**From:** Morne Theron <Morne.Theron@capetown.gov.za>  
**Sent:** Tuesday, 06 June 2017 12:10 PM  
**To:** Annei Kloppers  
**Cc:** Barry Wood; Pierre Maritz; Peter Flower; Deon Jeannes; Bulk Water Info; Kevin Balfour; Adél Groenewald  
**Subject:** Farm Duynfontein No 1552, Melkbosstrand: Hardened water reservoir at Koeberg Nuclear Power Station: Draft BAR \_ Eskom request to fill the proposed new Hardened water reservoir  
**Attachments:** CFM 1552 KNPS\_Hardened Water Tanks\_DBAR\_ City comment.pdf; Figure 1\_CTN-R51.pdf; NSC-007-17\_Permission to store water\_Koeberg.pdf

**CAPE FARM 1552 DUYNEFONTEIN: KOEBERG NUCLEAR POWER STATION PROPOSED HARDENED WATER RESERVOIR AND ASSOCIATED PIPING – DRAFT BASIC ASSESSMENT REPORT**  
**[City Reference: B21/1/2/2/13S]**  
**[DEA Reference: 14/12/16/3/3/1/1759]**

No.: CTN-R51

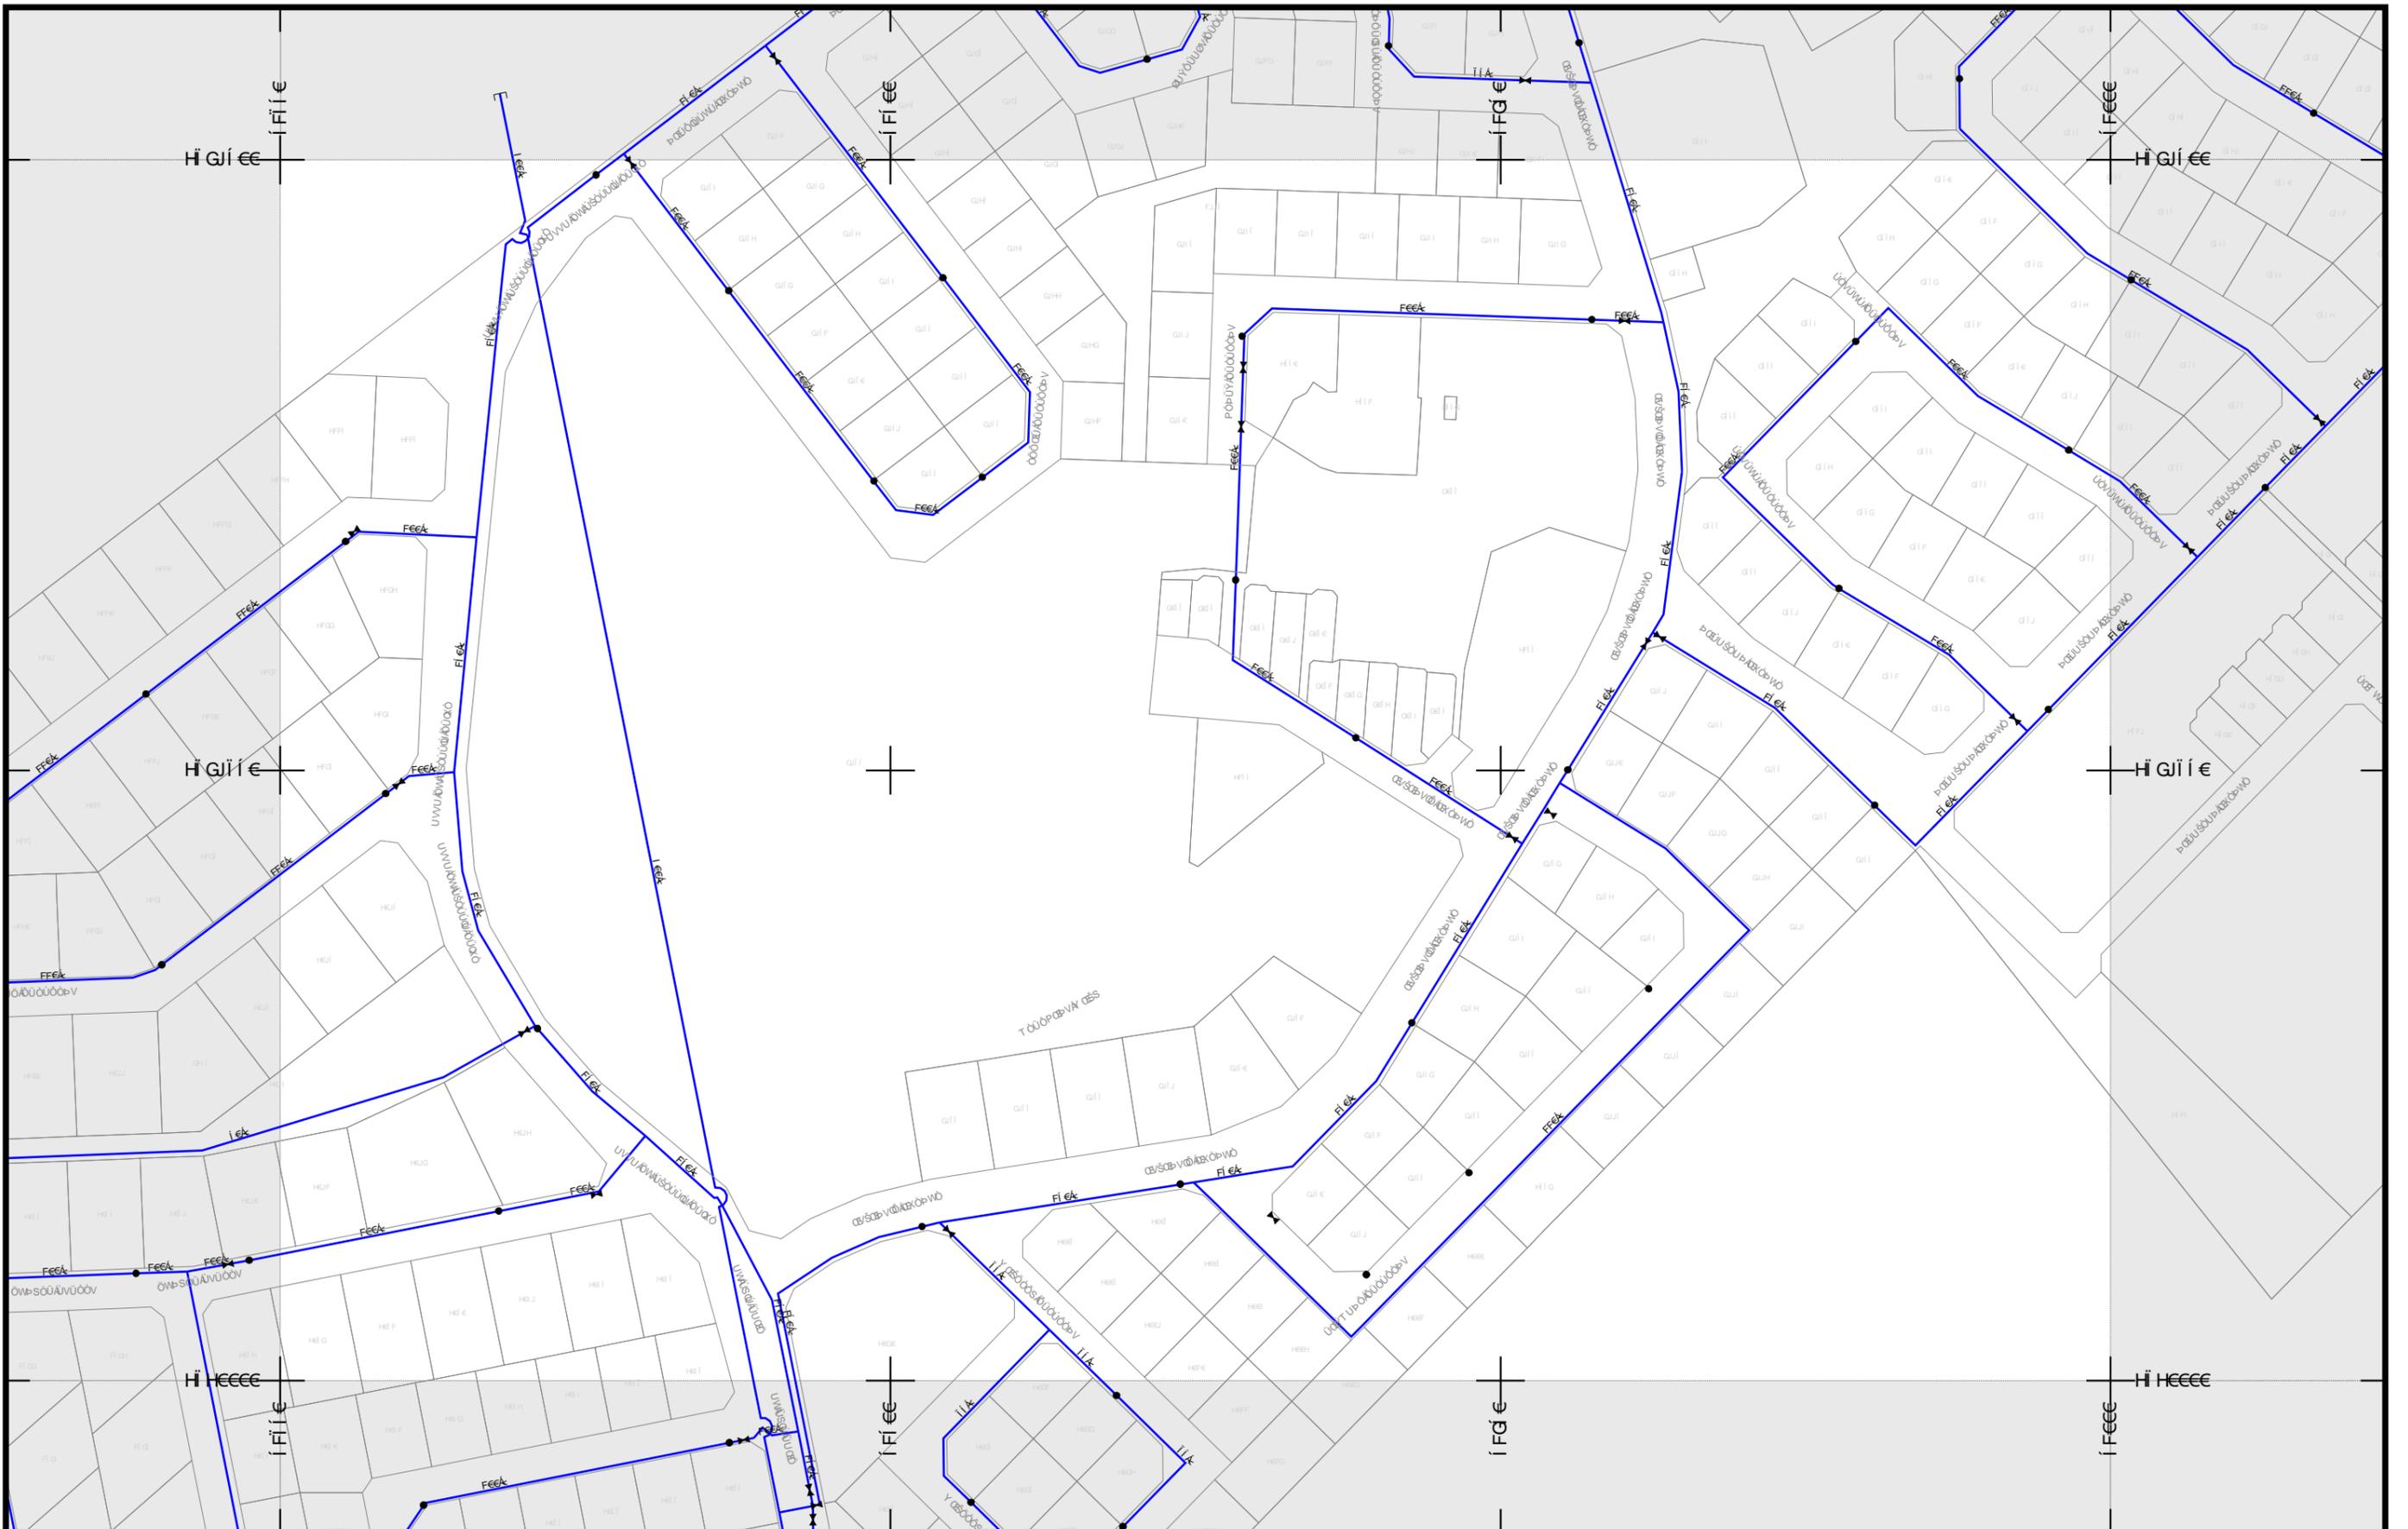
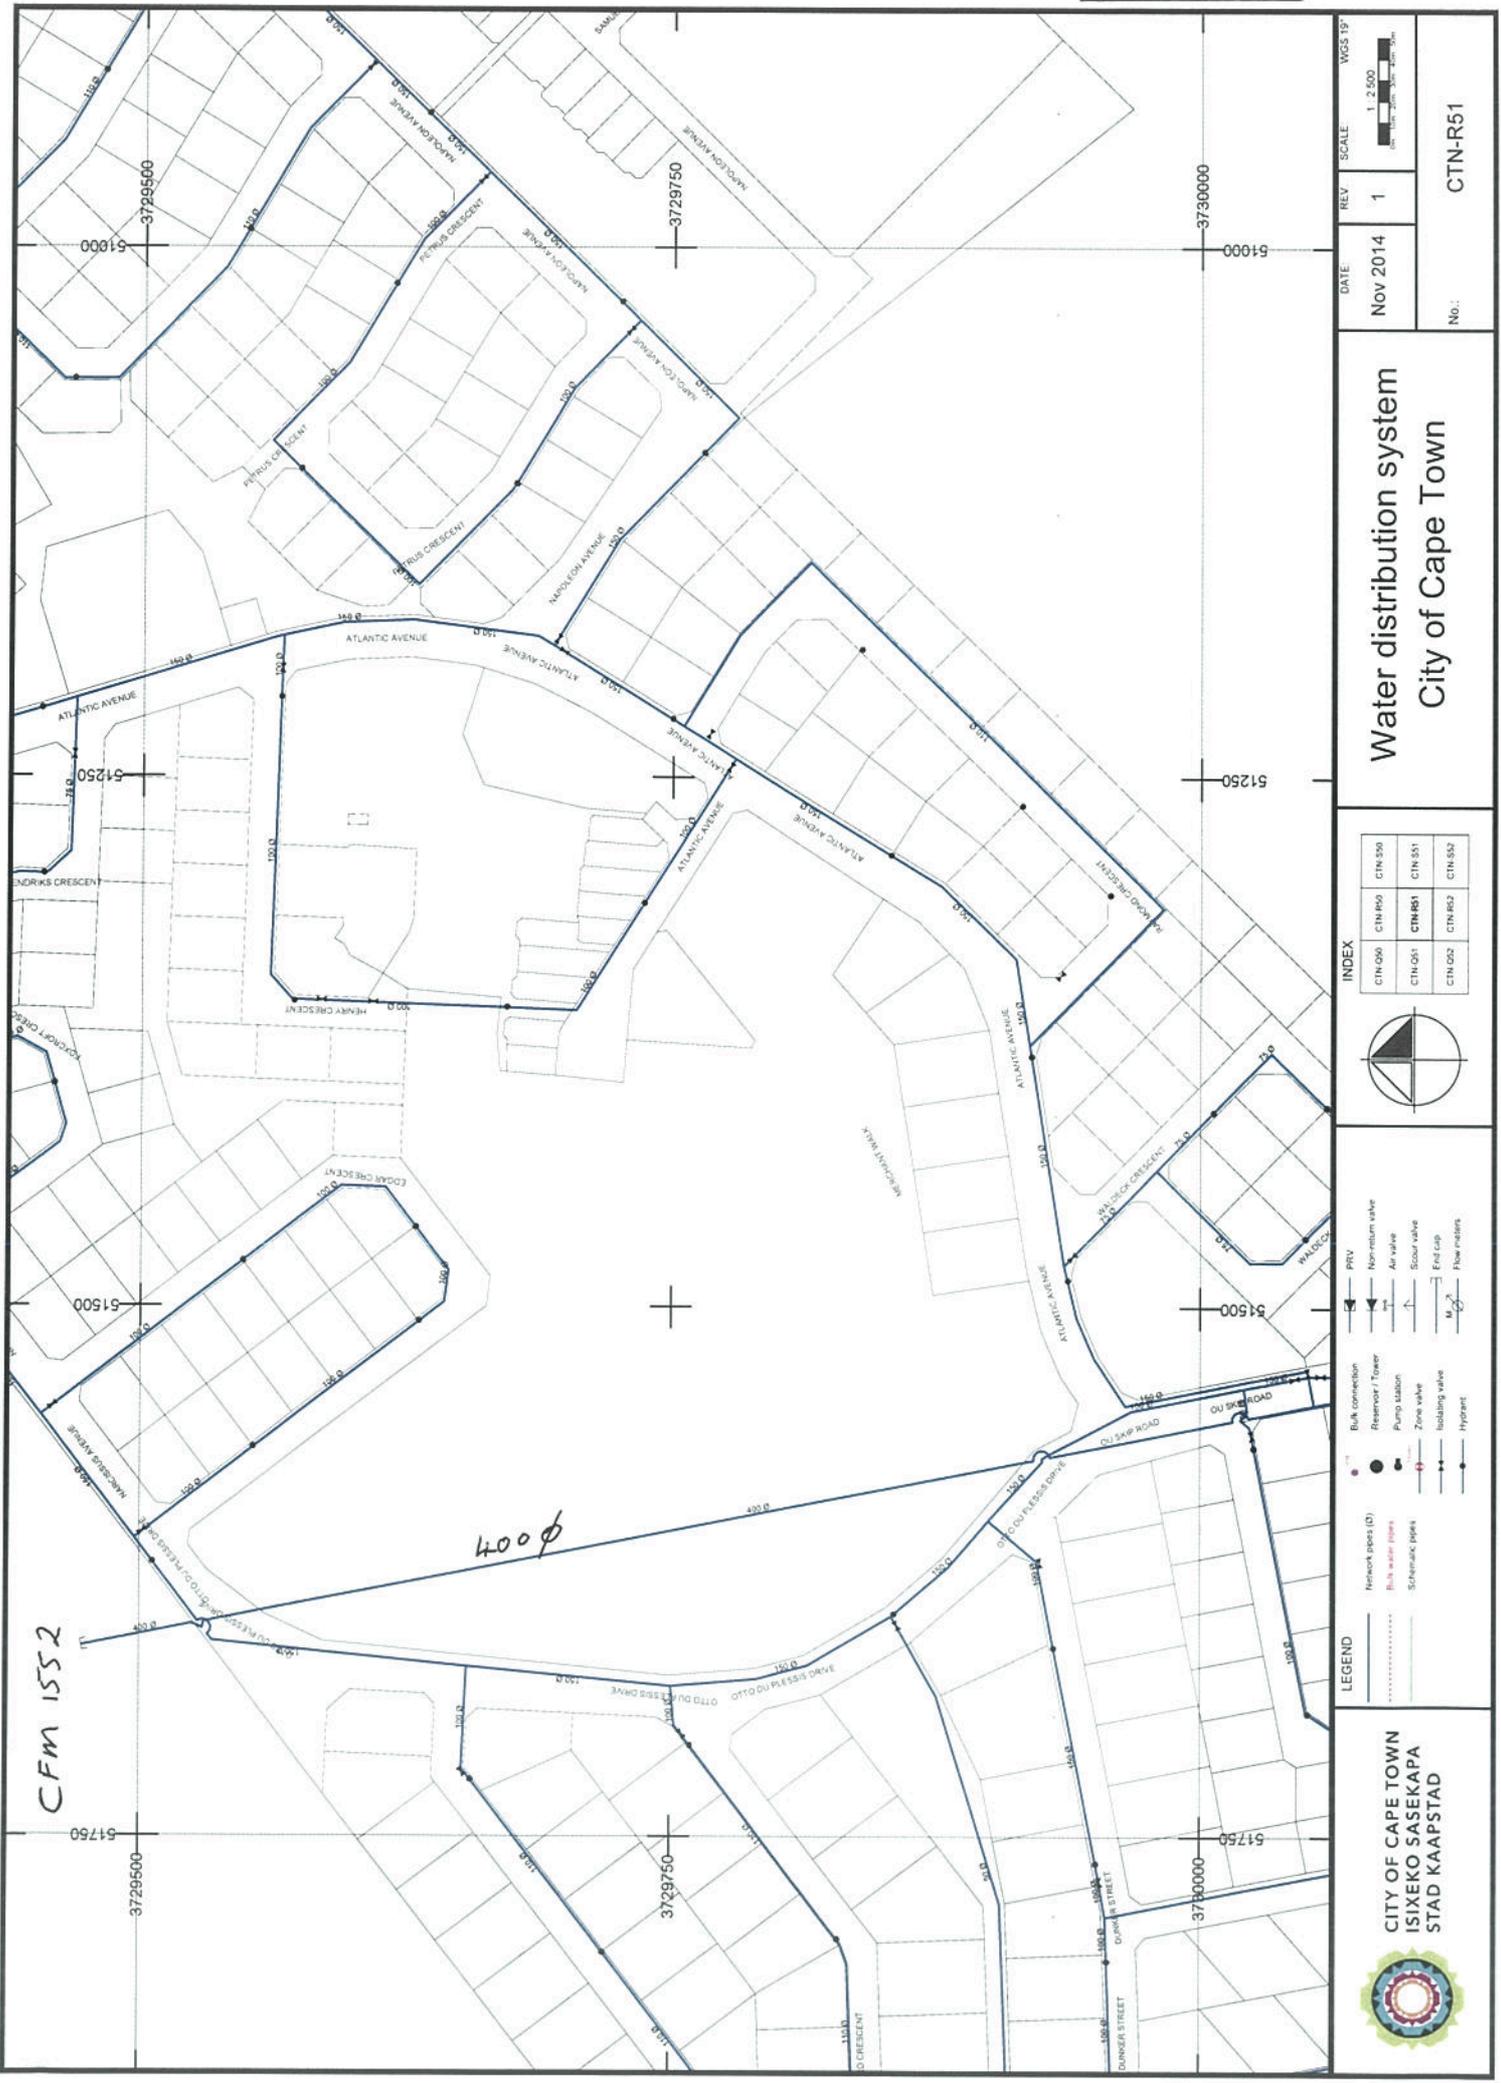
There is water supply to the southern boundary of the Cape Farm 1552 by means of the existing 400mm water supply located off Otto du Plessis Street (refer to the Water Distribution system plan, Drawing No: CTN-R51, attached Figure 1).

The peak pressure in the 400mm water main is about 74m. The 400mm supply is capable of delivering 144 l/s maximum. In practice this means it will take about 18,5 hrs to fill the reservoir.

[Note: There is also a 500mm water main along the Westcoast Road however the 500mm water main is dedicated to the far north (i.e. Atlantis , Pella and Mamre) and not suitable to draw from]
